**From:** [Max Hepp-Buchanan](#)  
**To:** [Eastman, Jeff R. - PDR](#); [Onufer, Kathleen M. - PDR](#)  
**Subject:** Bike Walk RVA comments on 17th St Farmers Market  
**Date:** Monday, February 01, 2016 12:45:12 PM  
**Attachments:** [Farmers Market Bike Walk RVA.pptx](#)  
[image001.png](#)

# 17TH STREET MARKET

## SITE CONNECTIONS

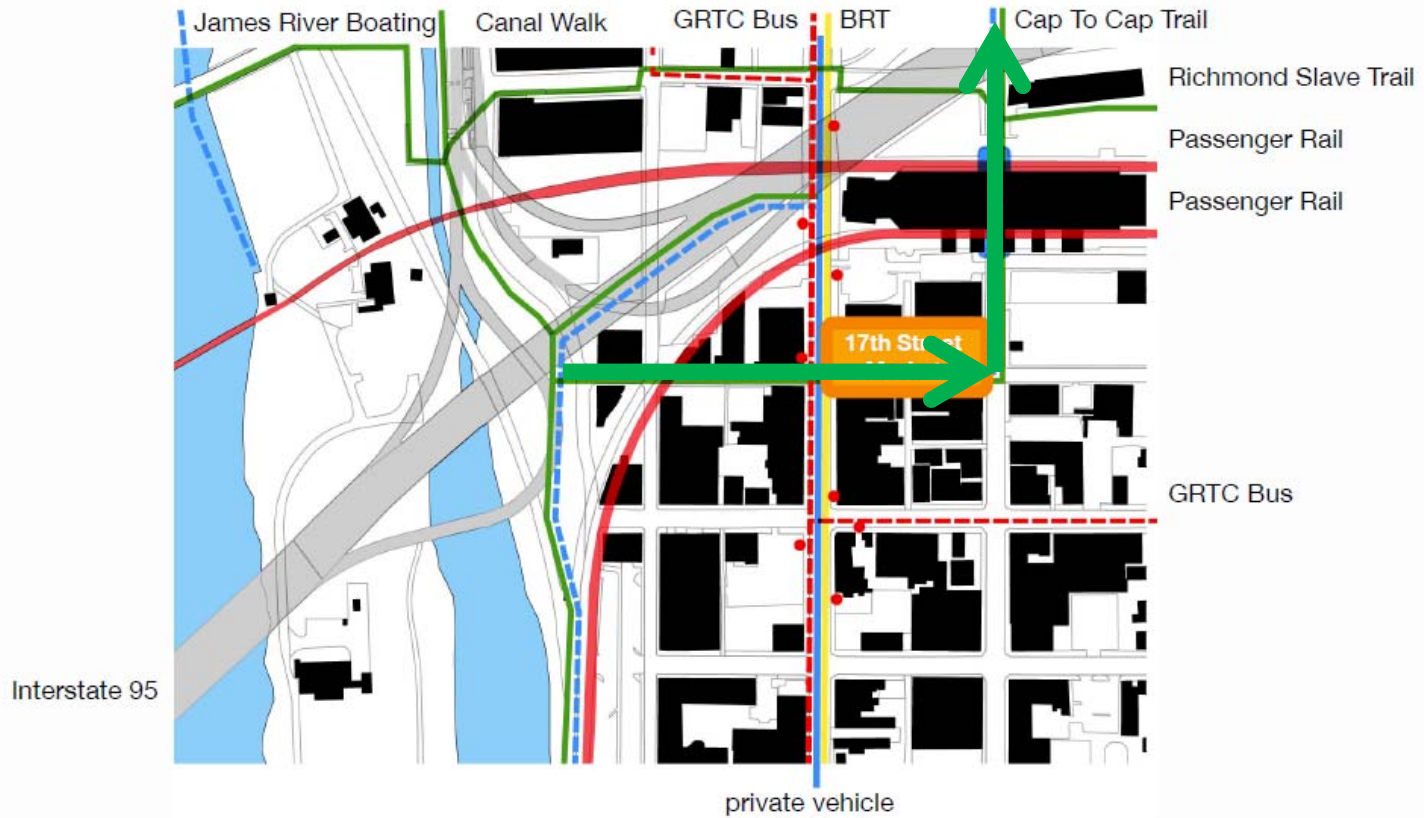
It is our understanding that the City of Richmond is proposing to use 17<sup>th</sup> St as a connector from the Virginia Capital Trail to the market and Main Street Station. The current proposal is to direct cyclists east from the Capital Trail on 17<sup>th</sup> and through the market to Franklin Street. At that point, they would turn left (north) and go under the train shed to continue on their way to the Capitol Building. I have emphasized that connection on the first slide of the attached PowerPoint file using drawn in green arrows.

PLAN

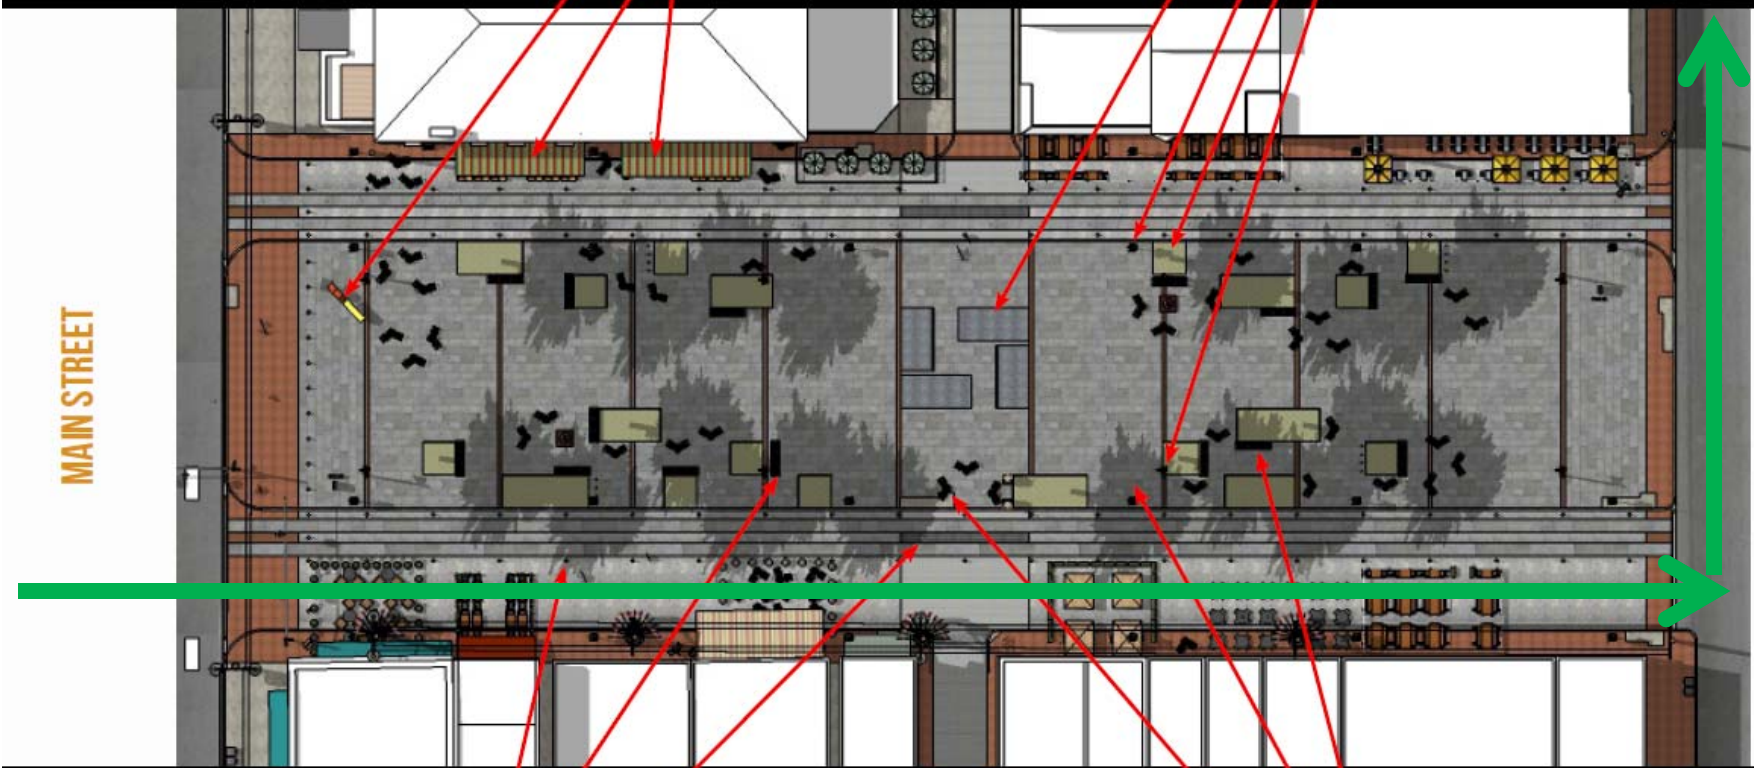
If that is the case, it is important for people on bikes to have a dedicated path through the market (from Main St to Franklin St) on the south side of the market. It will not be safe for the entire market to serve as a general “mixing area” of cyclists and pedestrians. While people on bikes should be encouraged/directed to ride slowly and carefully through the market, channeling them through a particular area of the market using bollards, planter boxes, or other physical barrier will help to avoid confusion and potential conflicts. People on foot should be able to cross the bikeway, but there should also be signage warning them that they are stepping into a bikeway and to look both ways. I have emphasized that connection on the second slide of the attachment using green arrows.

Requiring people on bikes to dismount when entering the market is not recommended, as most people on bikes will end up avoiding the market entirely as a result, both as a destination and as a through-way to Main Street Station or the Capitol Building.

Finally, cobblestones are uncomfortable and dangerous for most people to ride on, and are particularly difficult for children to handle. Any bike route to or through the market should not be surfaced with cobbles. We realize there is a historical context to consider, but we recommend surfacing the bike routes through the market and along Franklin Street with bricks instead of cobbles. Even embedding a five-foot wide brick path into the cobbled streets in each direction for cyclists to use would be greatly preferred.
